DEVELOPMENT ASSESSMENT CASE NUMBER: CD-2022-0002 – 311-315 South Congress Planned Unit Development

COMMENT REPORT

CASE NUMBER: CD-2022-0002
CASE MANAGER: Wendy Rhoades

PROJECT NAME: 311 - 315 South Congress PUD

garza		7708 Rialto Blvd., Suite 125 Austin, Texas 78725 Tel: (512) 298-3284 Fax: (512) 298-2592 TBPE # F-14629 GarzaEMC, LLC © Copyright, 2022	
REVISION		DATE	
NO.		DATE	
LAND USE PLAN		SOUTH CONGRESS PUD	
DRAWN BY:		DESIGNED BY:	
QA / QC:		PROJECT NO.: 113874-0001	
SHEET		EXH 1	
OF		---

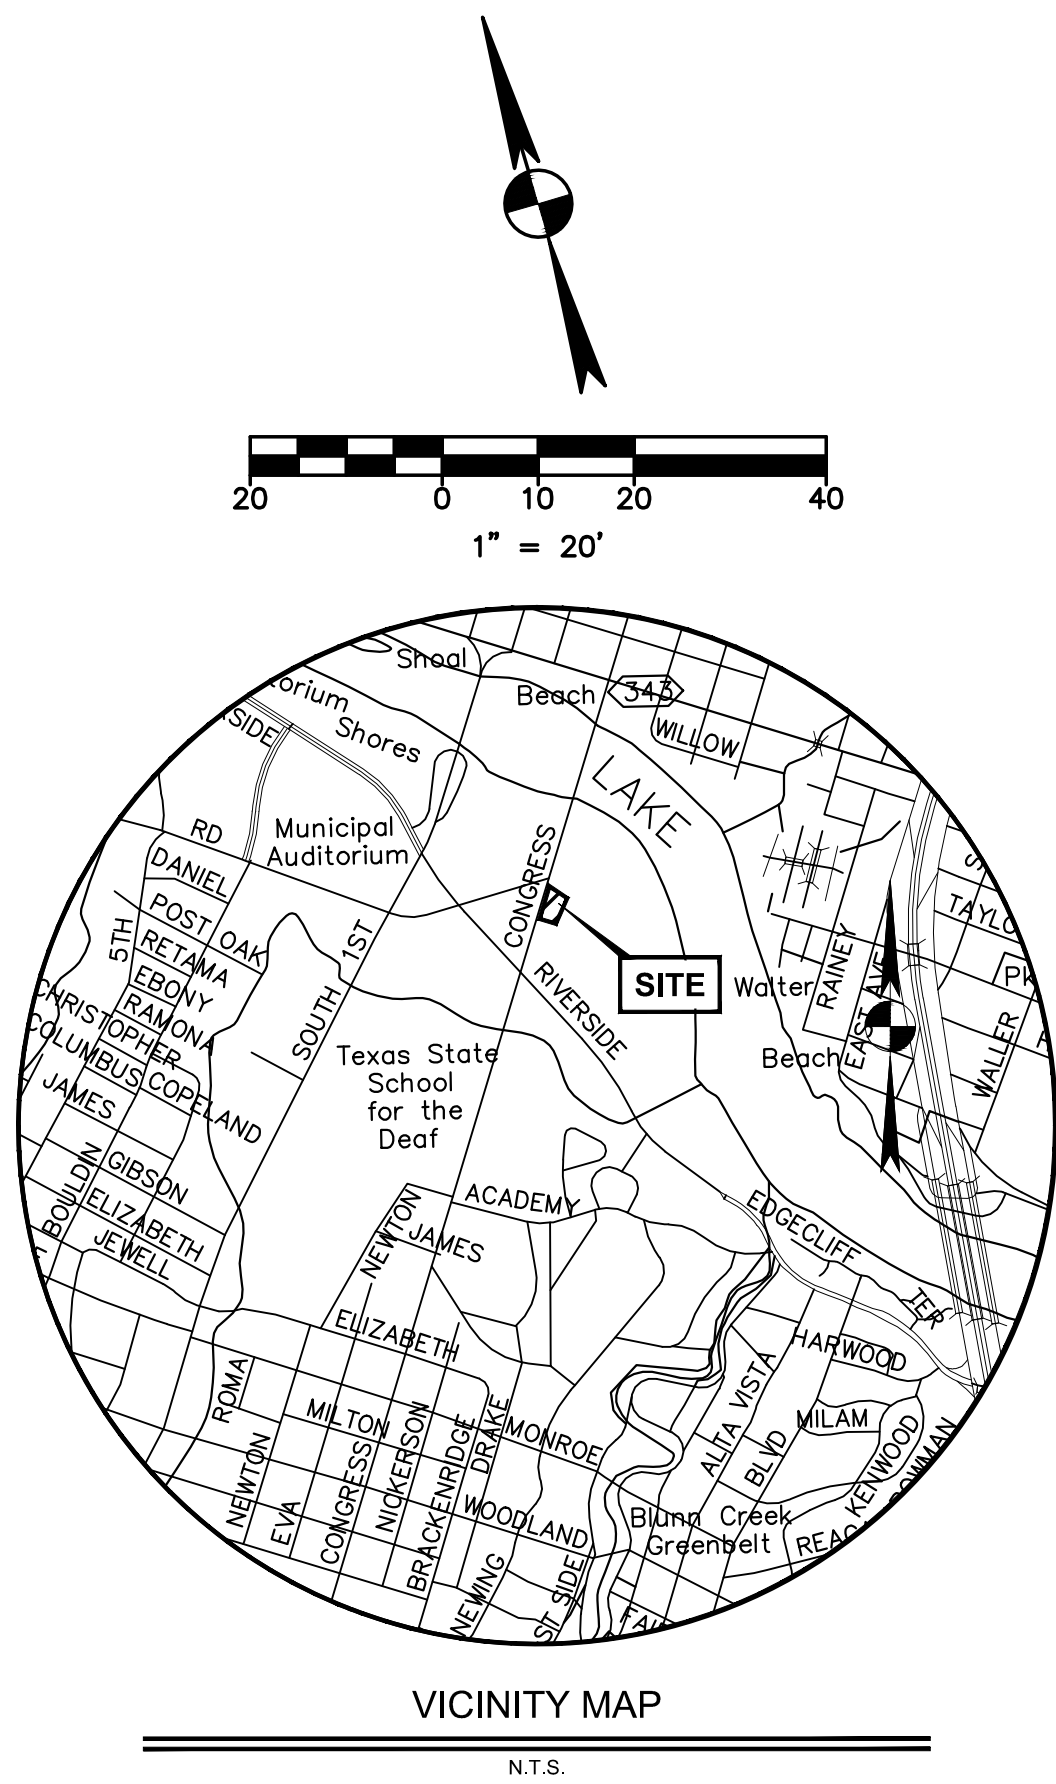
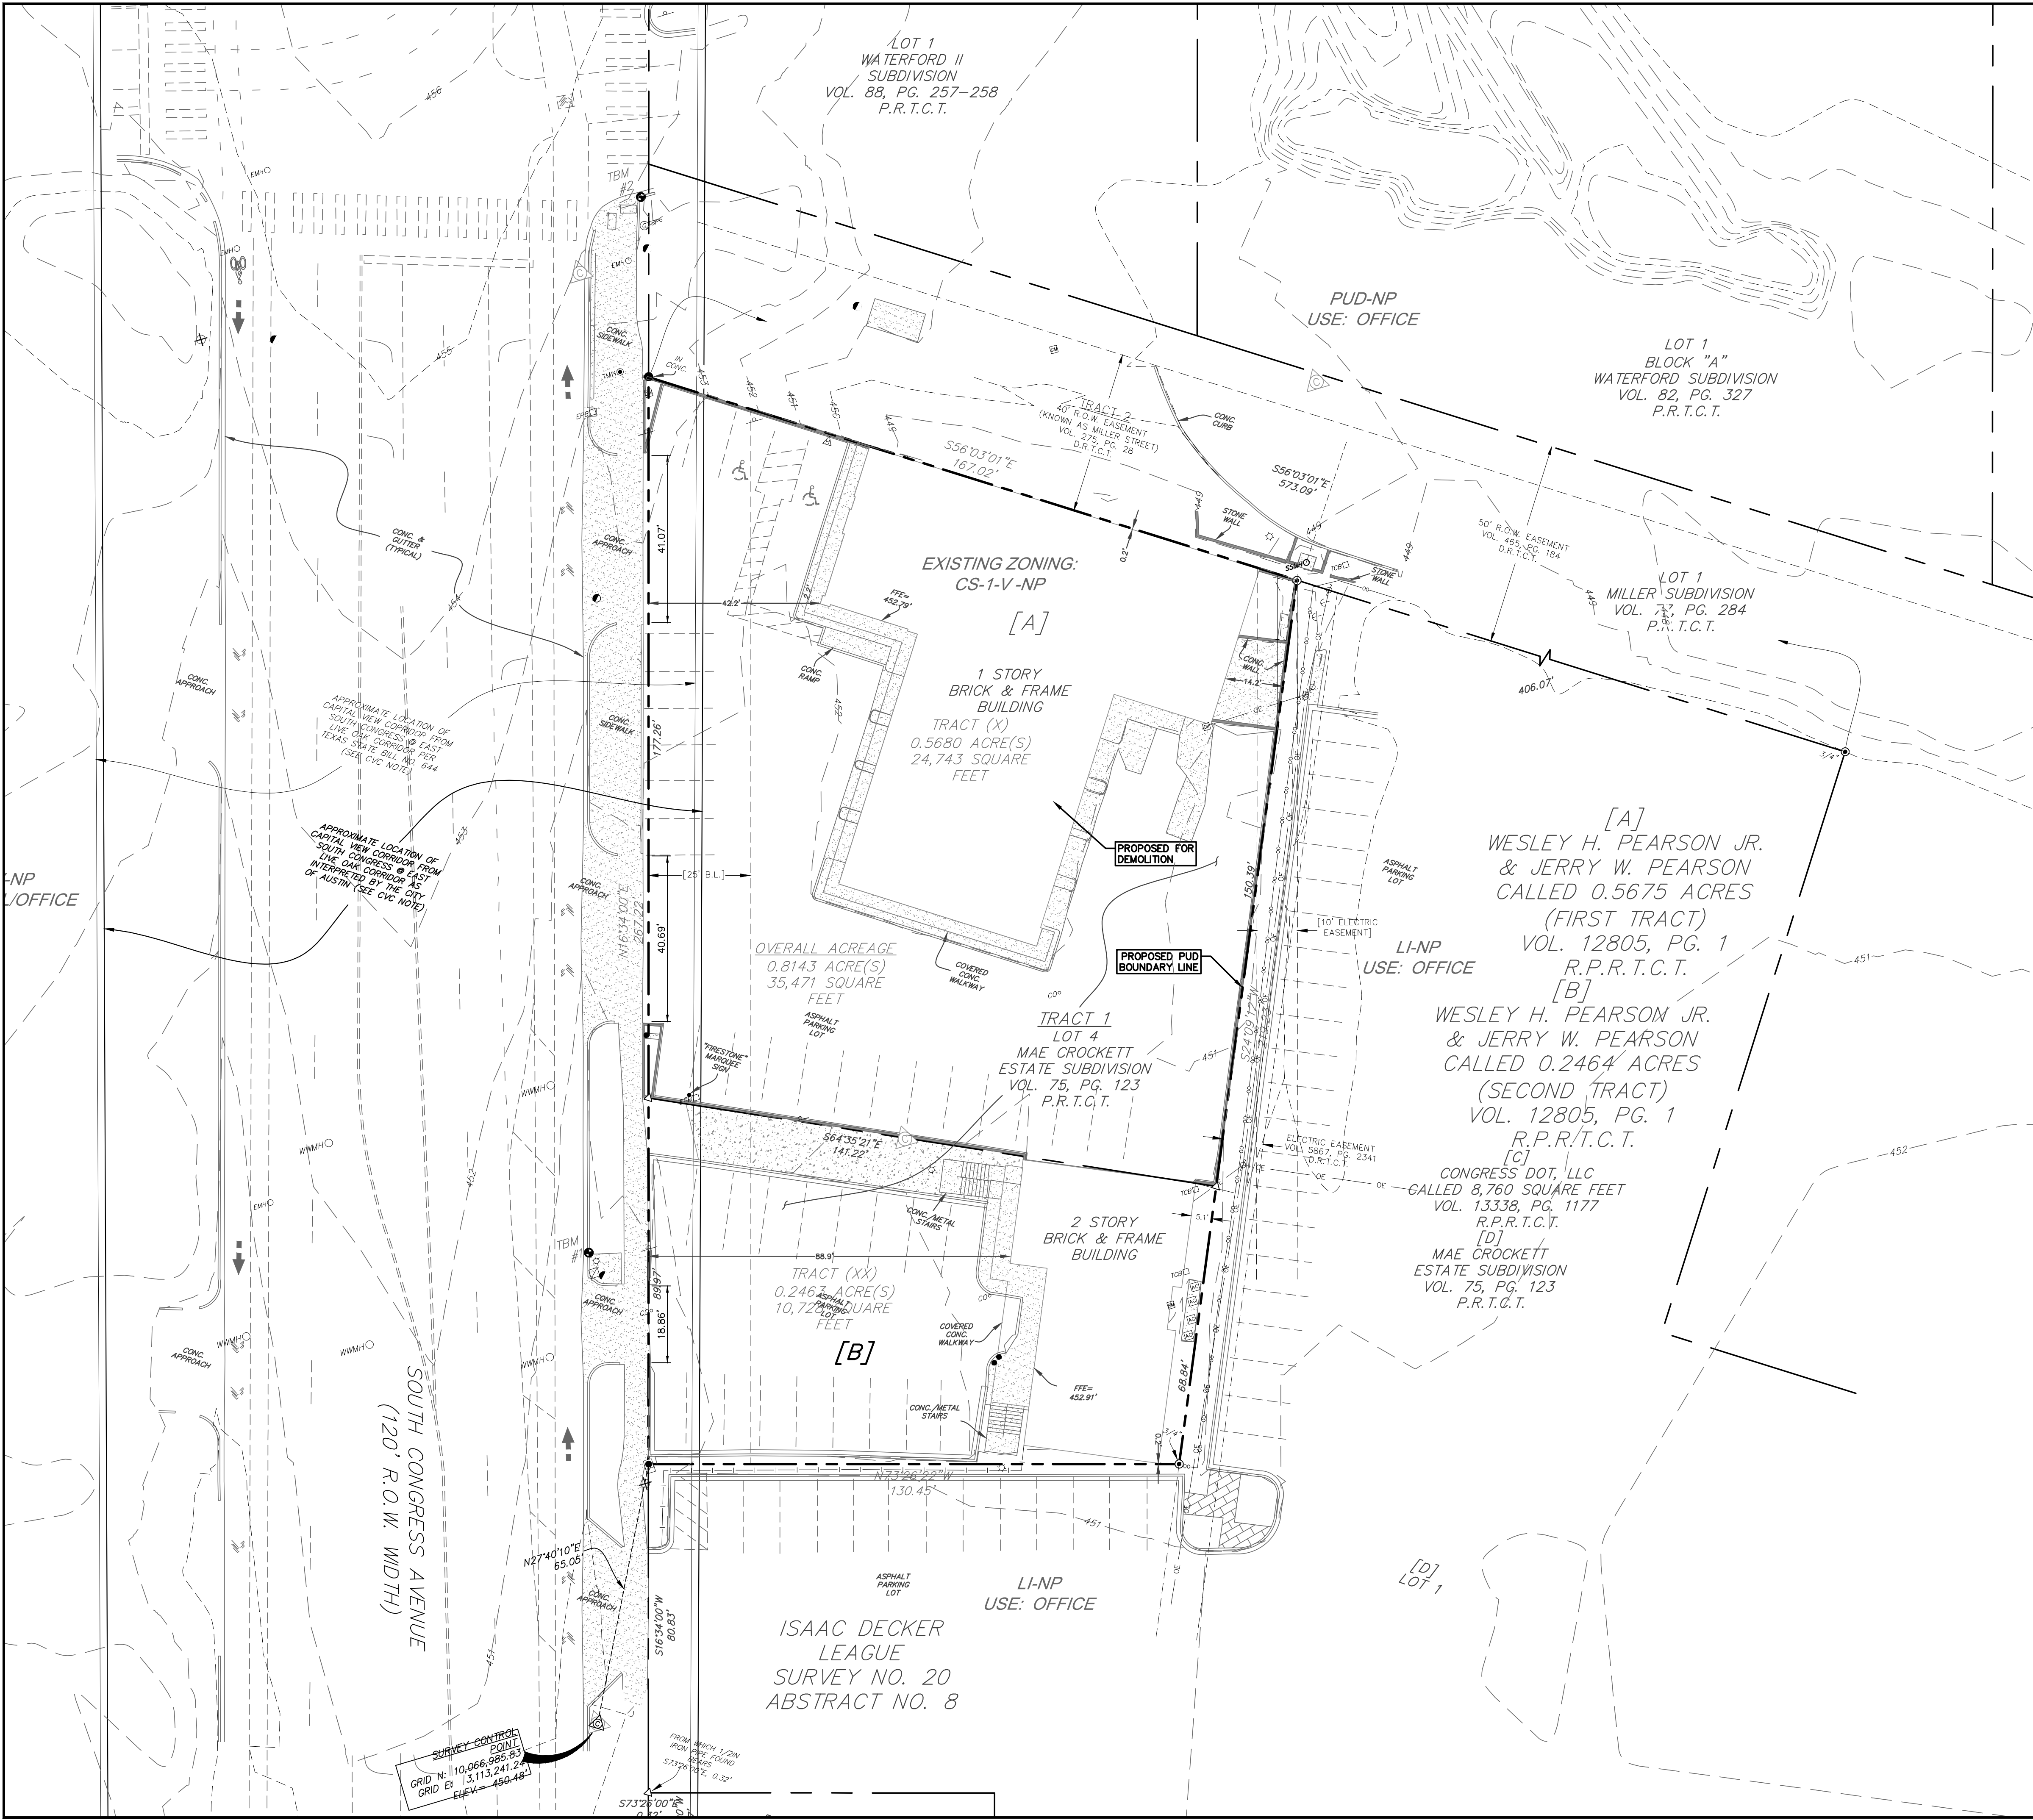
ZN 3. Add proposed Land Use Summary table that includes proposed uses (residential, office, and ground floor pedestrian-oriented use) and corresponding square footages to the Land Use Plan.
